STATE OF HAWAII
DEPARTMENT OF TRANSPORTATION
HIGHWAYS DIVISION

ADDENDUM NO. 4

INTERSTATE ROUTE H-1 ADDITION AND MODIFICATION OF FREEWAY ACCESS (KAPOLEI INTERCHANGE COMPLEX), PHASE 3

FEDERAL-AID PROJECT NO. NH-H1-1(271)

PAVEMENT DETAIL (2 / T-13)

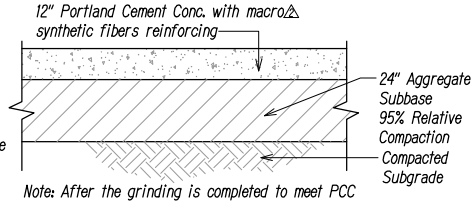
DATE	REVISION
△ 12/6/2022	Added Macro-Synthetic fibers
△ 11/17/2022	Revised Title of detail 9/T-13

36. Spec Section 719 – Macrofibers for Concrete Reinforcement. Please clarify where this is required.

See Addendum No. 4 Det. 2/T-13 Pavement Detail.

SIGNAGE AND STRIPING PLAN 1

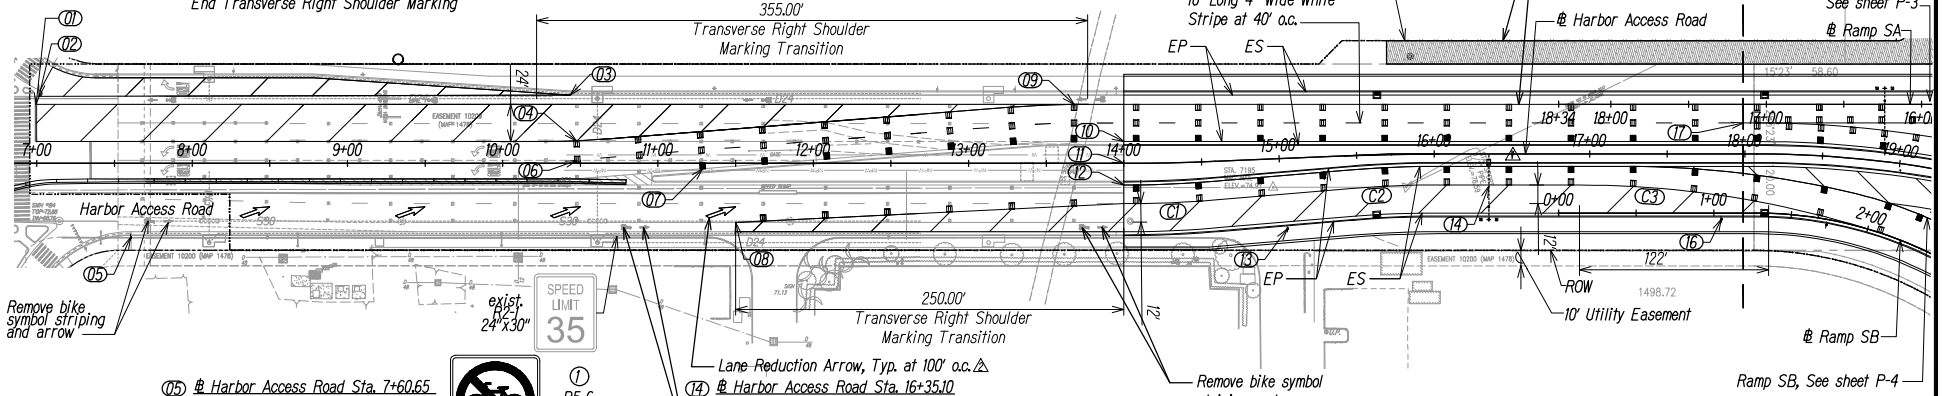
DATE	REVISION
12/6/2022	Revised Reduction Arrow Spacing
11/17/2022	Removed Road Closed Sign

TRAFFIC CONTROL PLAN - RAMP SA SEQUENCE 1

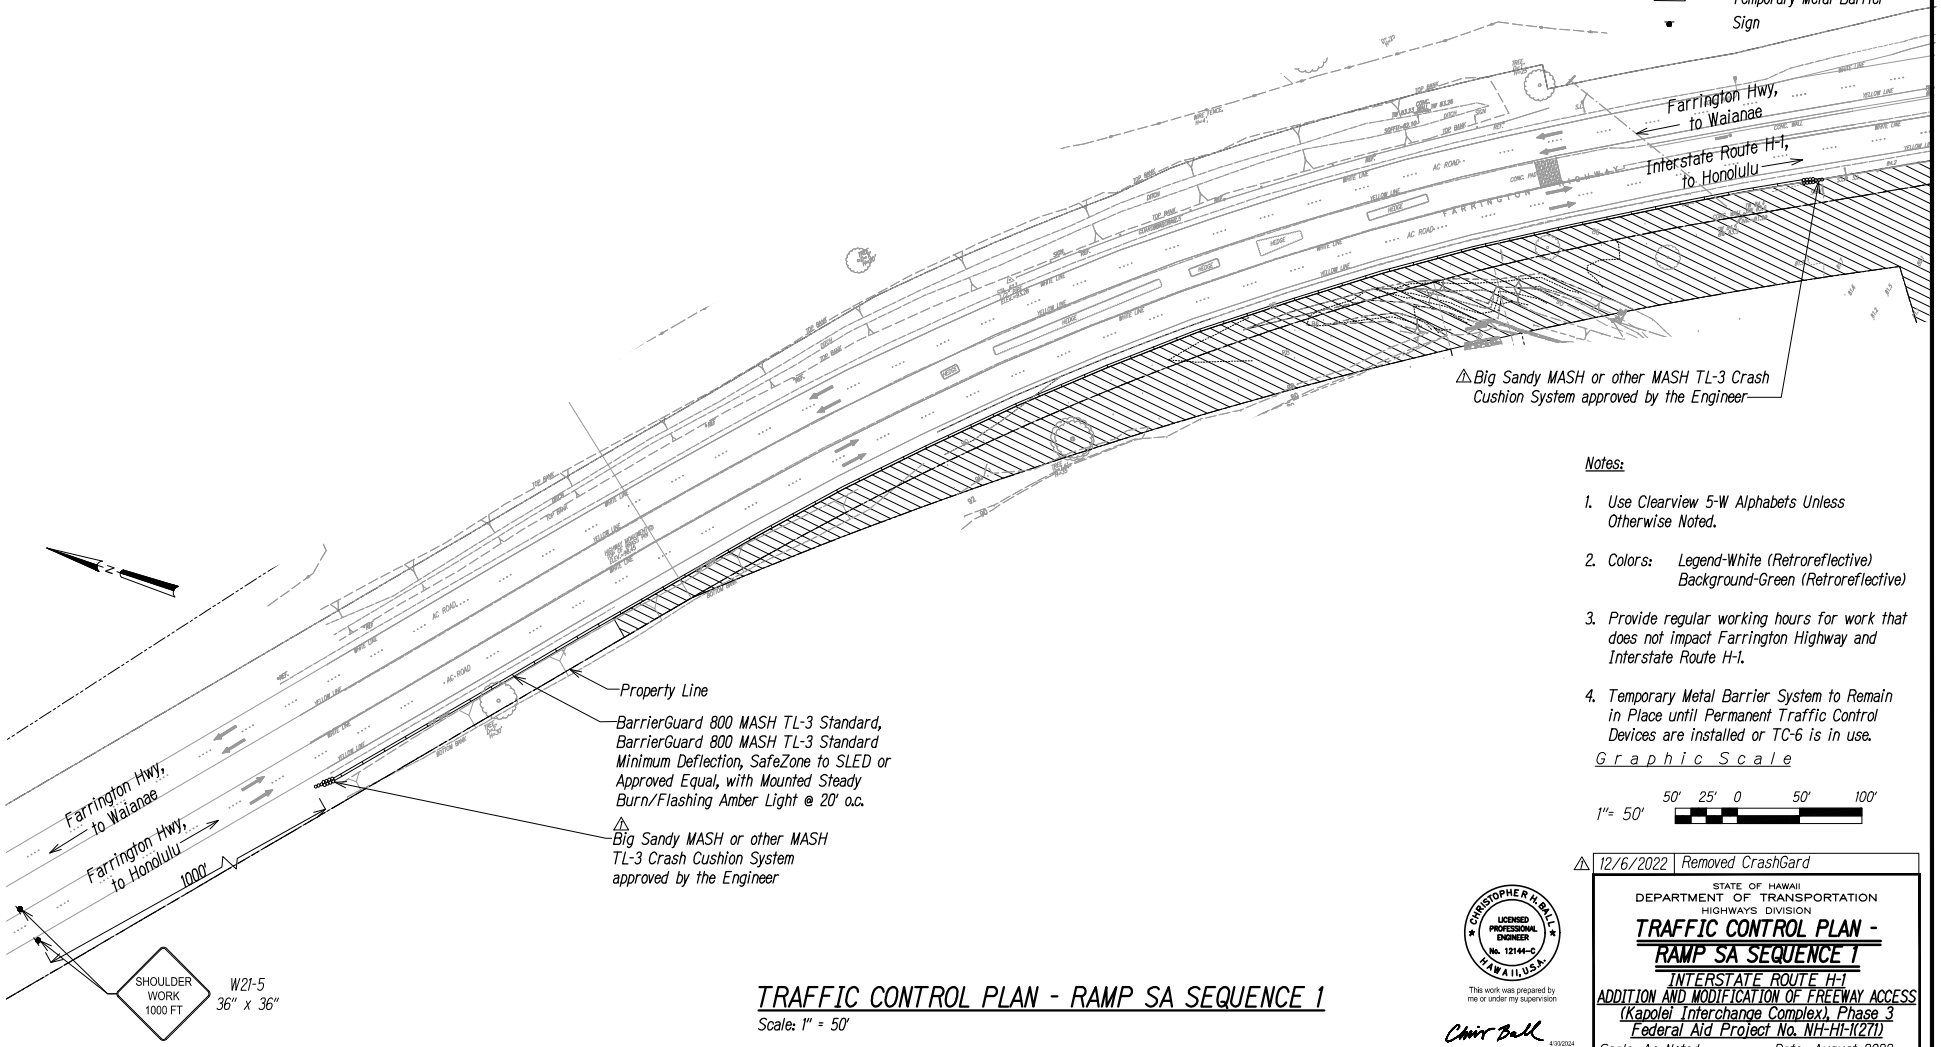
⚠	12/6/2022	Removed CrashGard

TRAFFIC CONTROL PLAN - RAMP SA SEQUENCE 2

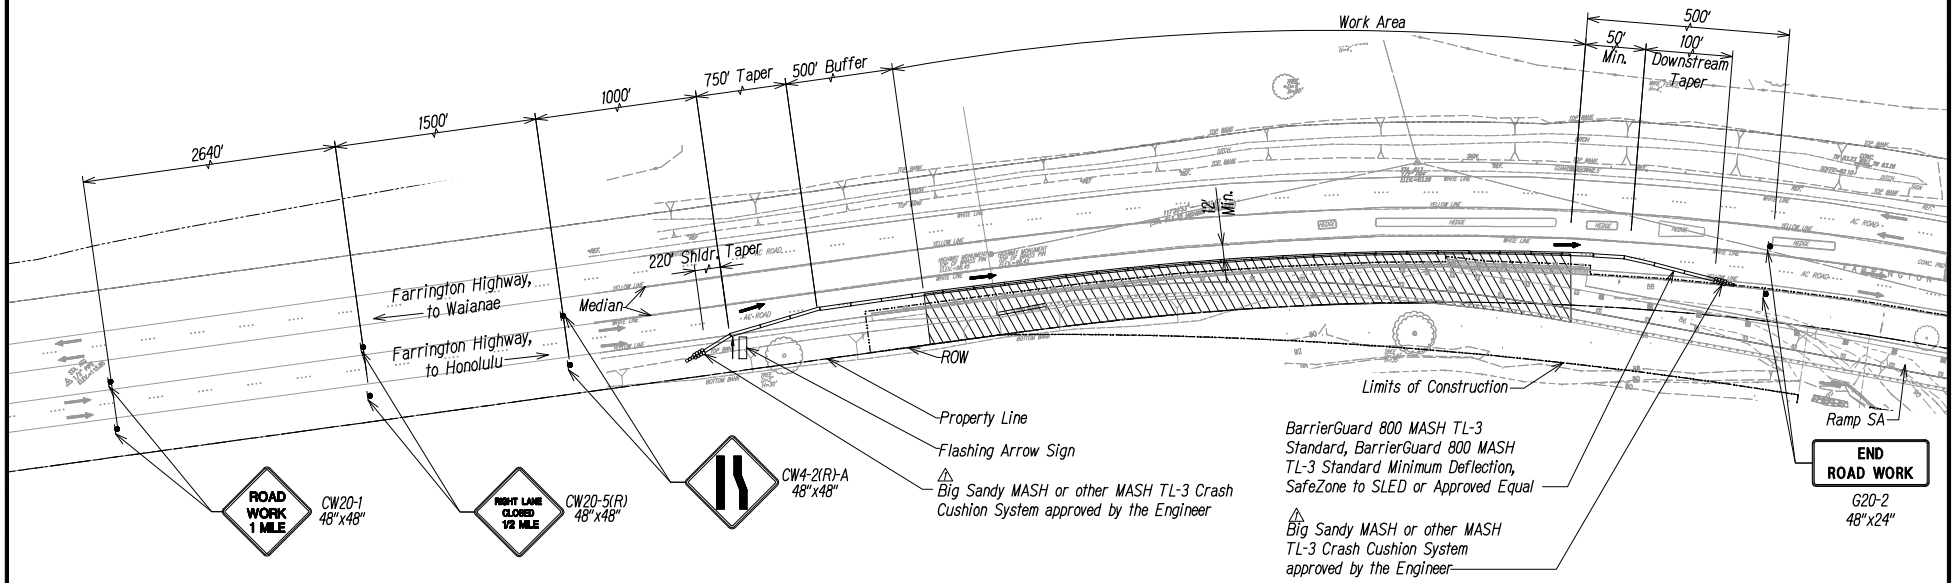
⚠	12/6/2022	Removed CrashGard

TRAFFIC CONTROL PLAN - RAMP SB SEQUENCE 3

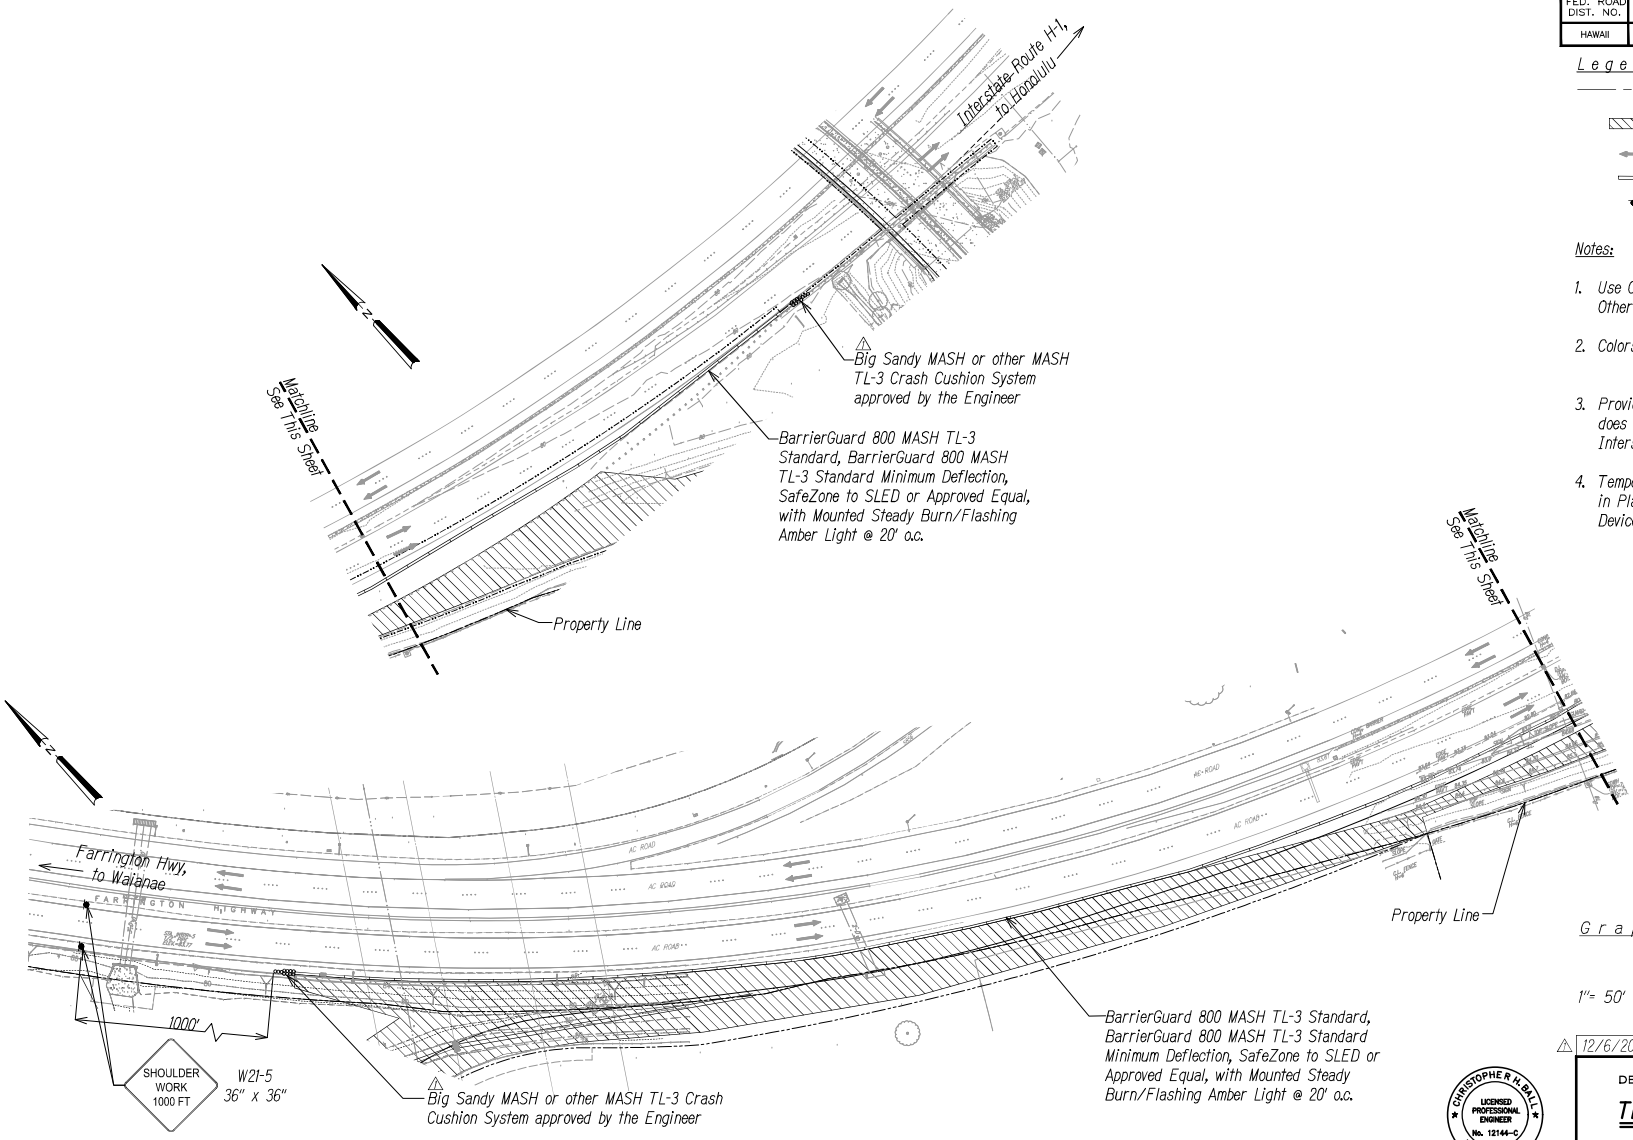
12/6/2022	Removed CrashGard

TRAFFIC CONTROL PLAN - HARBOR ACCESS ROAD SEQUENCE 3

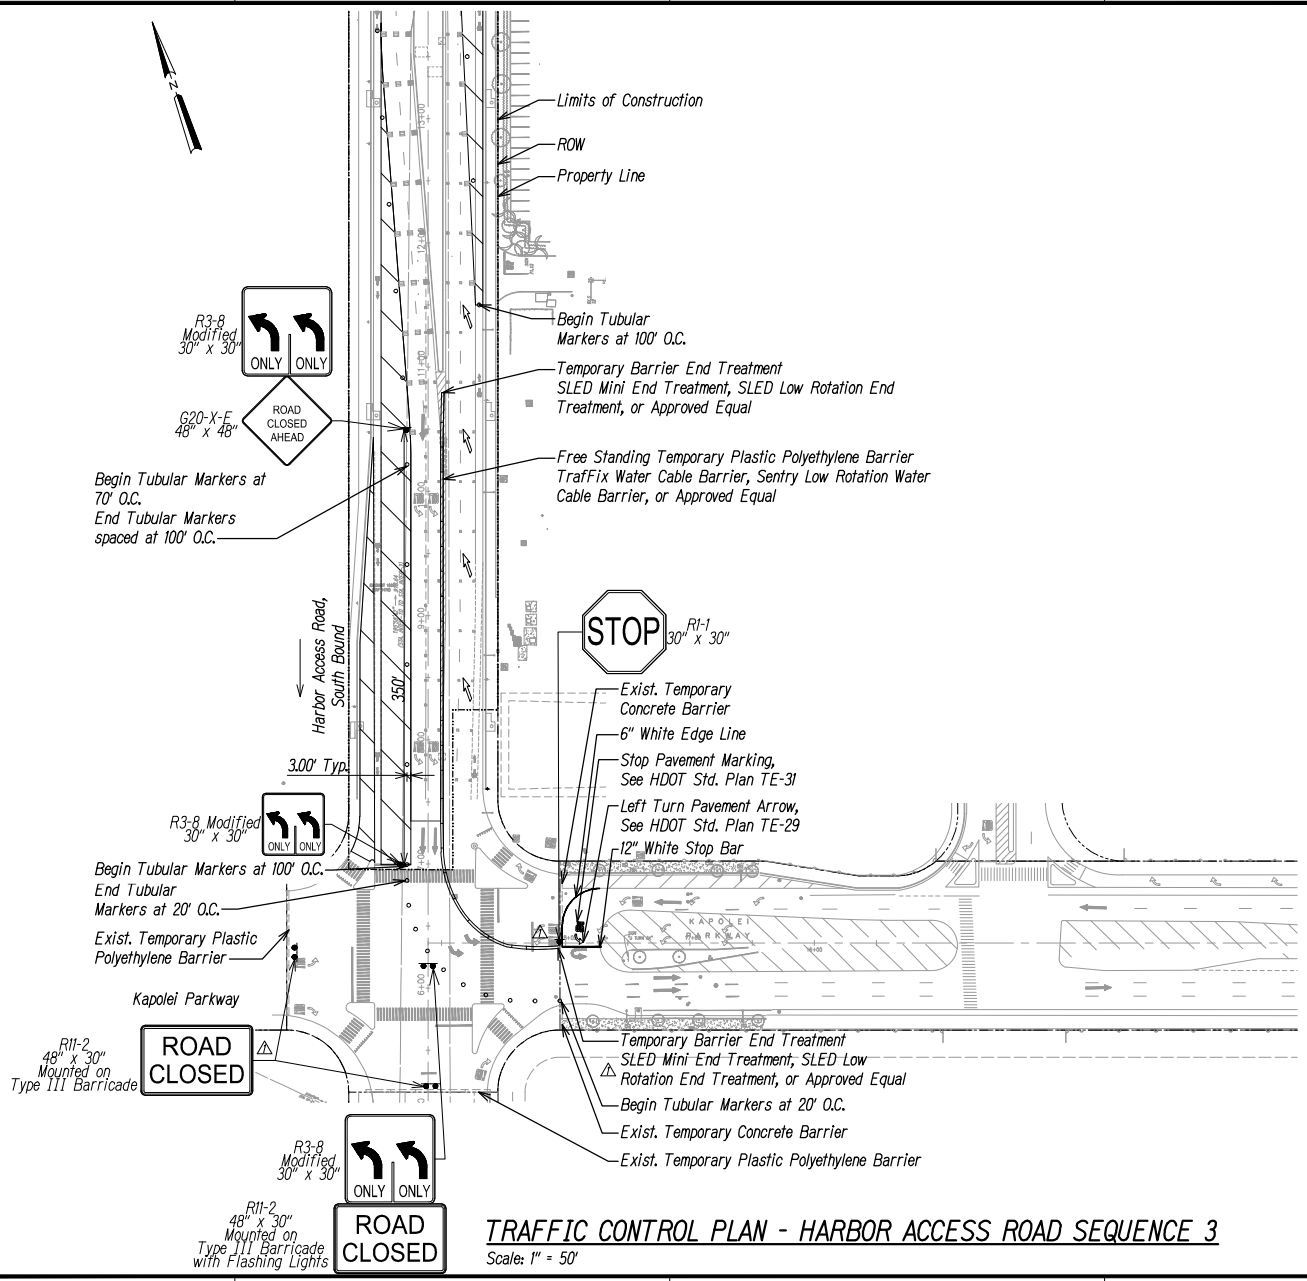
⚠	12/6/2022	Revised Traffic Control

TRAFFIC CONTROL PLAN - RAMP SB SEQUENCE 4

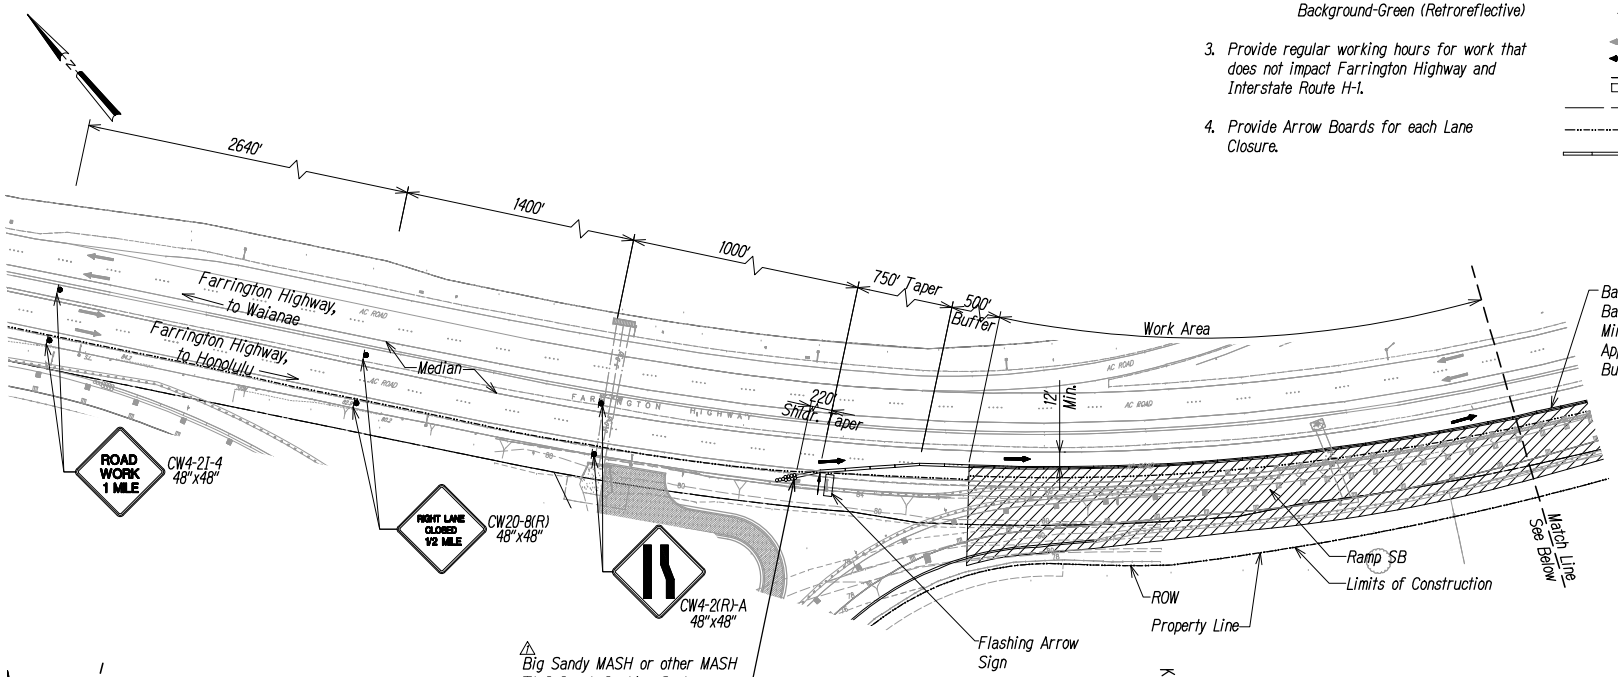
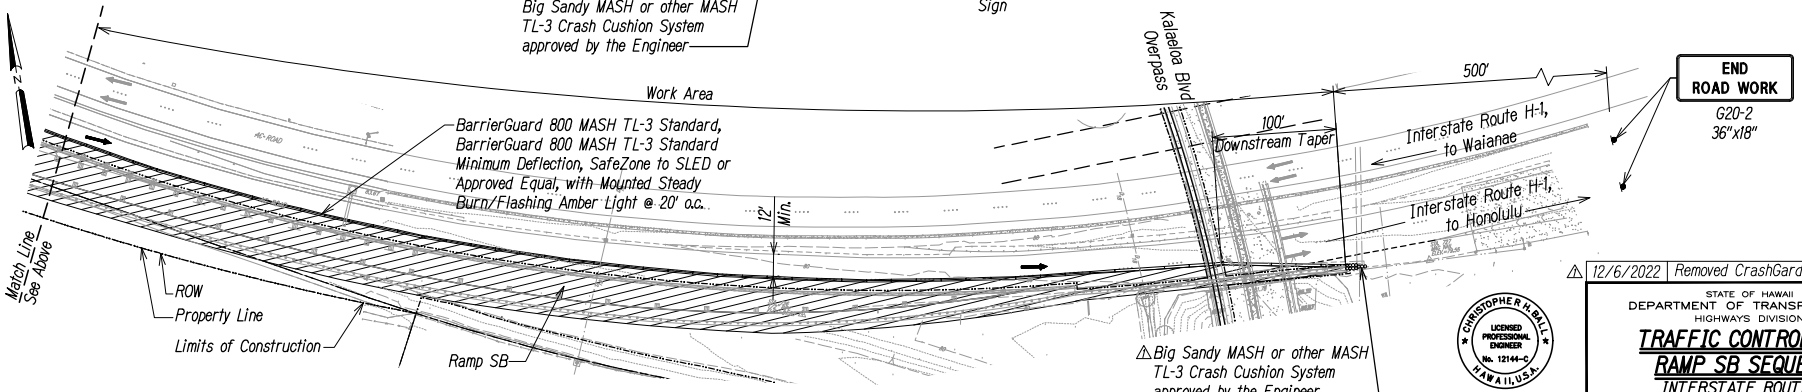
⚠	12/6/2022	Removed CrashGard

TRAFFIC CONTROL PLAN - HARBOR ACCESS ROAD SEQUENCE 5

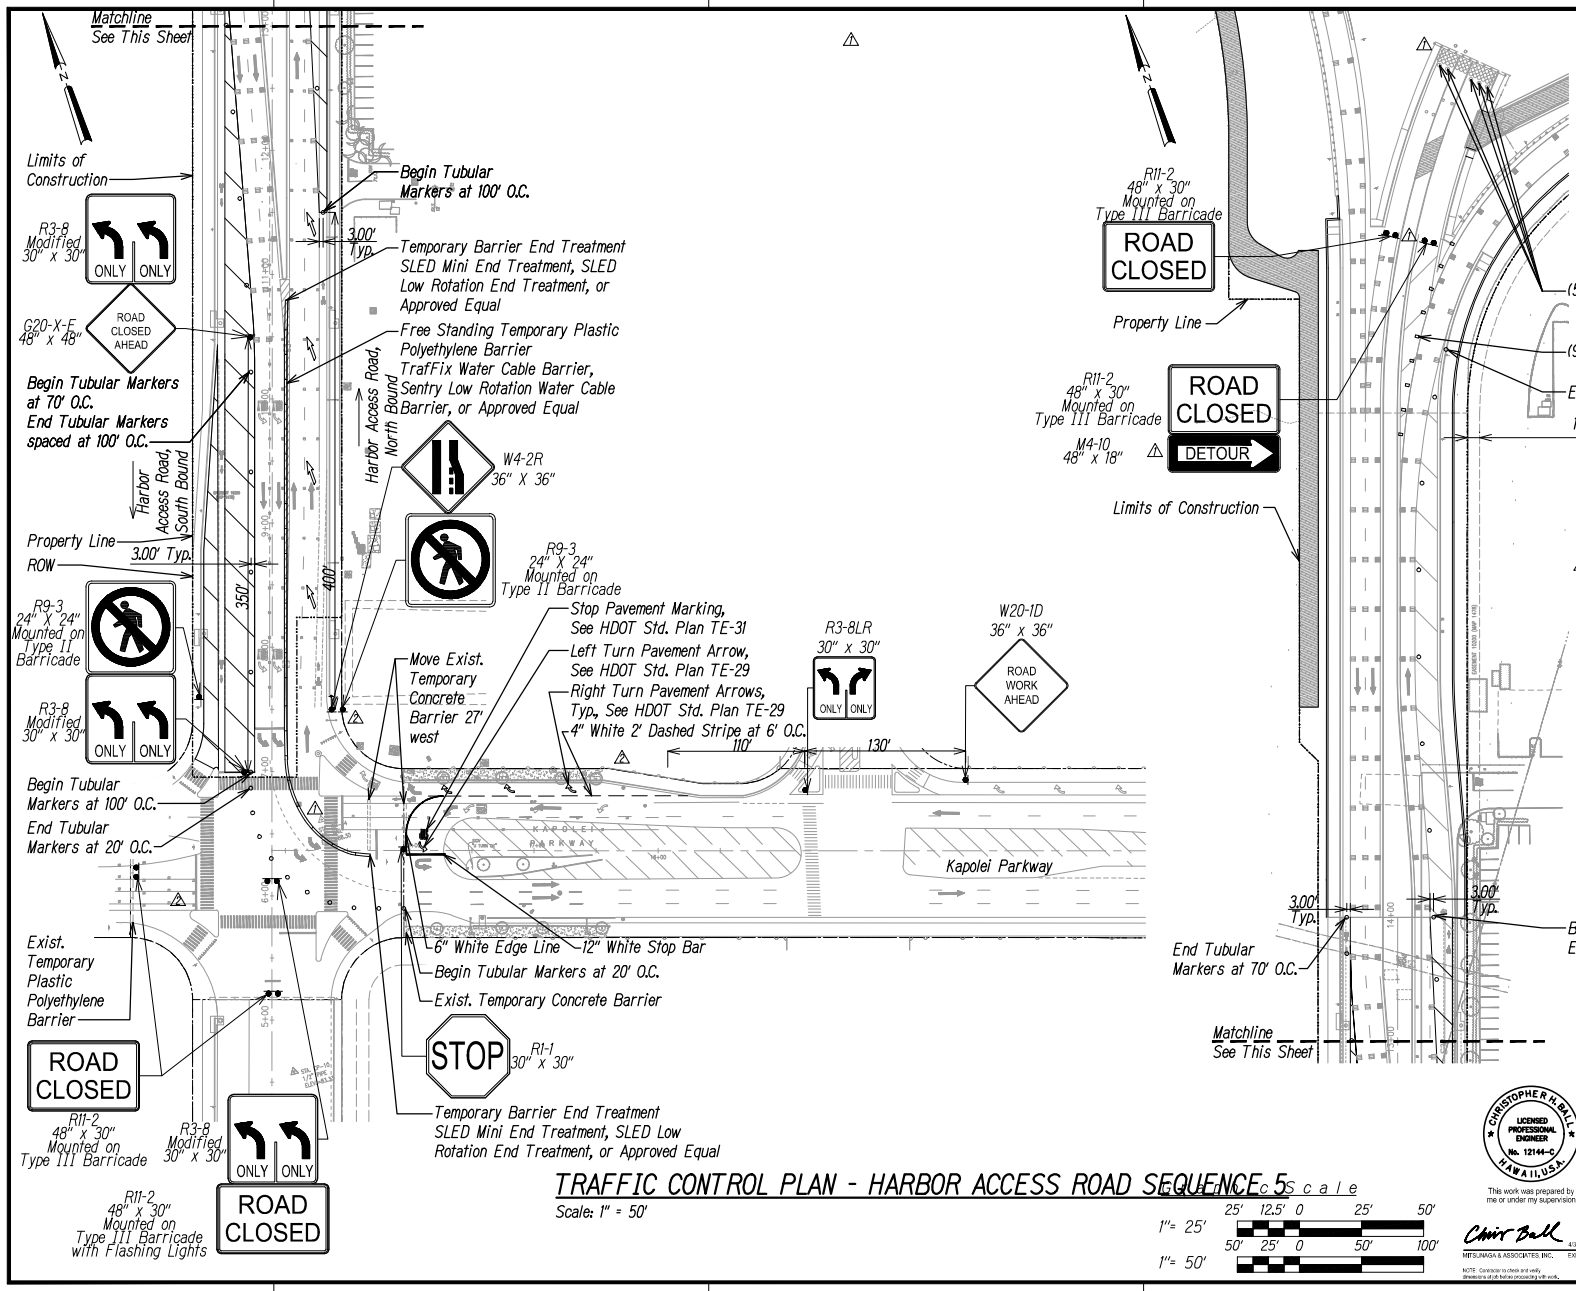
DATE	REVISION
12/6/2022	Revised Traffic Control
11/17/2022	Revised Traffic Control
